UNITED STATES PATENT AND TRADEMARK OFFICE

Office Action Summary

10/733,512

DETAILED ACTION

Fig. 1

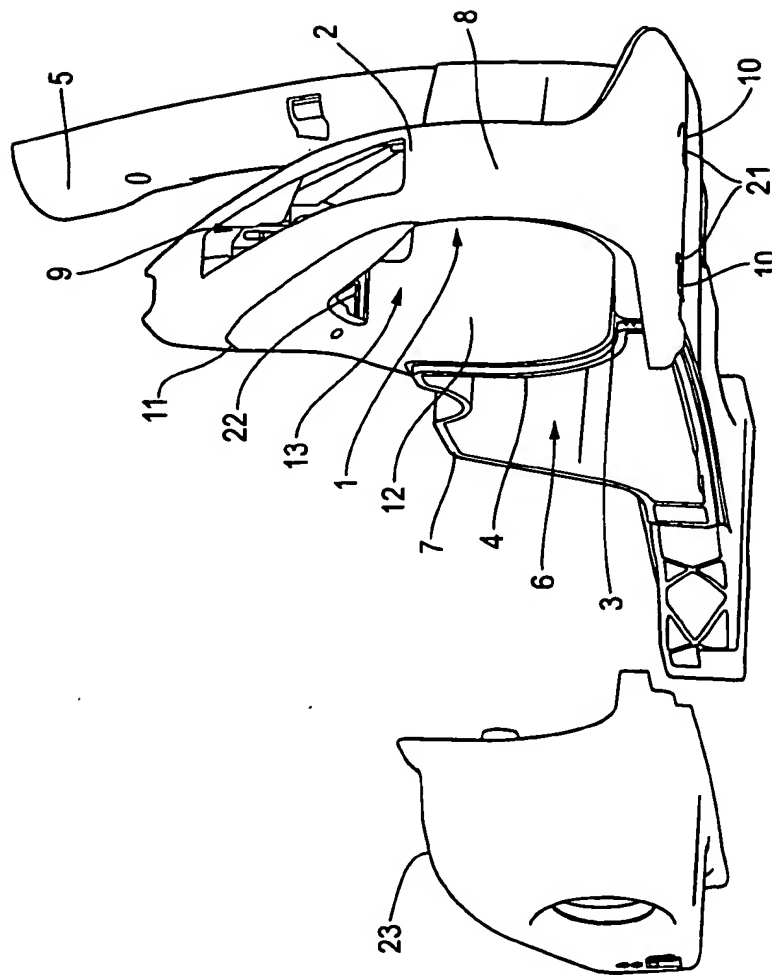
Green teaches portion 20a which is capable of receiving the foot of the user for support. Also, applicant's handle shell 8 is not covering the foot portion 3, which is located on top of the lower portion 19 of the handle shell.
